ADDENDUM No. 2 TO ORIGINAL INVITATION TO BID

DATE: September 28, 2018

BID No.: 5549-2019 Milling and Resurfacing of Tennis Courts at Chiles High School

**CHILES
 HIGH SCHOOL -
 TENNIS COURT
 MILLING &
 RESURFACING**

SHEET TITLE:
ASPHALT PAVING PLAN

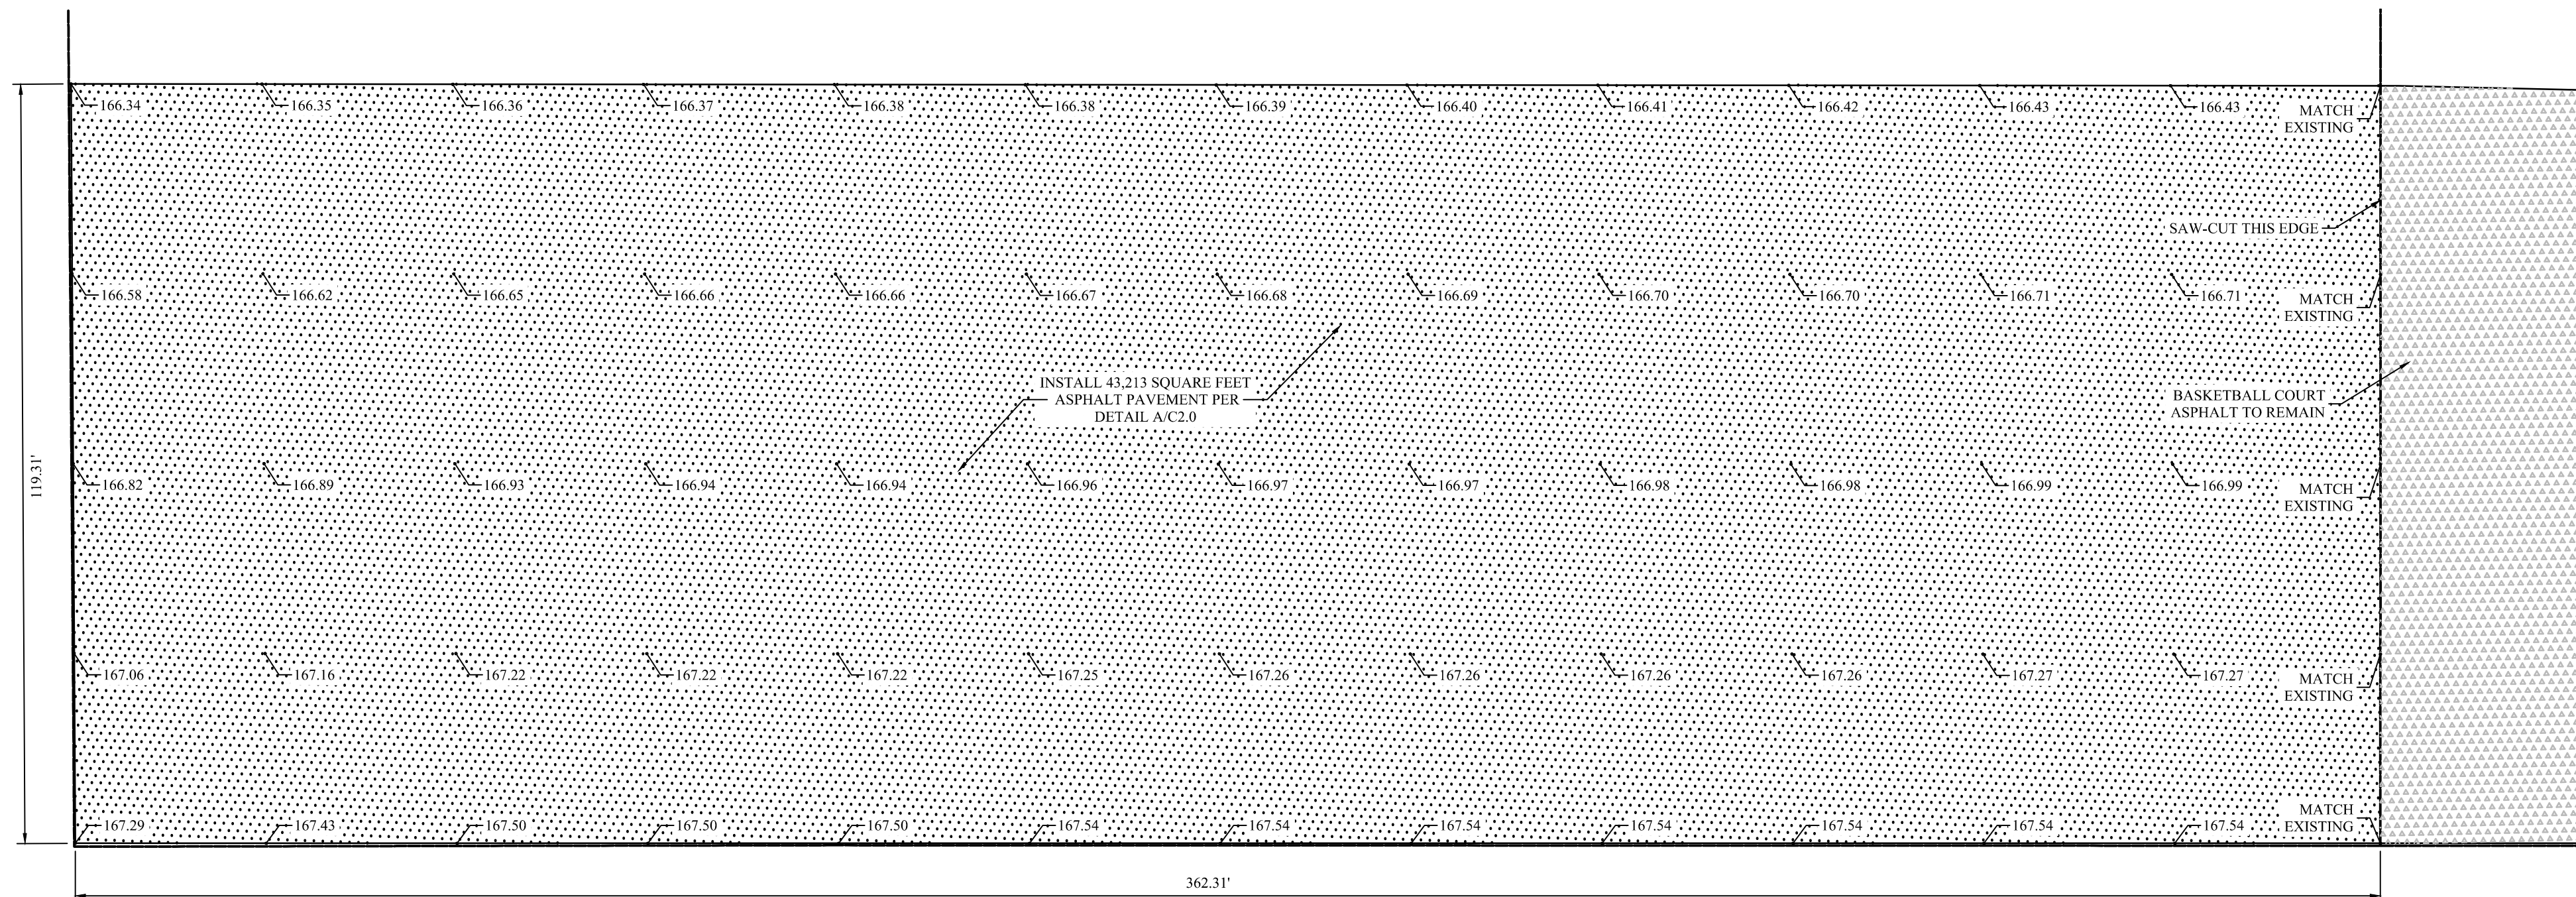
2. THE EXISTING FENCE POST AND TENNIS NET POST BASES WILL BE REMOVED BY THE LEON COUNTY SCHOOL BOARD. THE HOLES ARE TO BE FILLED WITH BASE AND MEET THE COMPACTION REQUIREMENTS OF FDOT STANDARD SPECIFICATIONS SECTION 285 OPTIONAL BASE GROUP 4. THE LEON COUNTY SCHOOL BOARD WILL BE RESPONSIBLE FOR PAYING AND SCHEDULING ALL MATERIAL TESTING.
3. THE CONTRACTOR IS TO FULLY RESTORE ANY AND ALL DAMAAGE TO THE CHILES HIGH SCHOOL PROPERTY DUE TO CONSTRUCTION ACTIVITY TO PRE-CONSTRUCTION CONDITIONS.

2. THE EXISTING FENCE POST AND TENNIS NET POST BASES WILL BE REMOVED BY THE LEON COUNTY SCHOOL BOARD. THE HOLES ARE TO BE FILLED WITH BASE AND MEET THE COMPACTION REQUIREMENTS OF FDOT STANDARD SPECIFICATIONS SECTION 285 OPTIONAL BASE GROUP 4. THE LEON COUNTY SCHOOL BOARD WILL BE RESPONSIBLE FOR PAYING FOR AND SCHEDULING ALL MATERIAL TESTING.
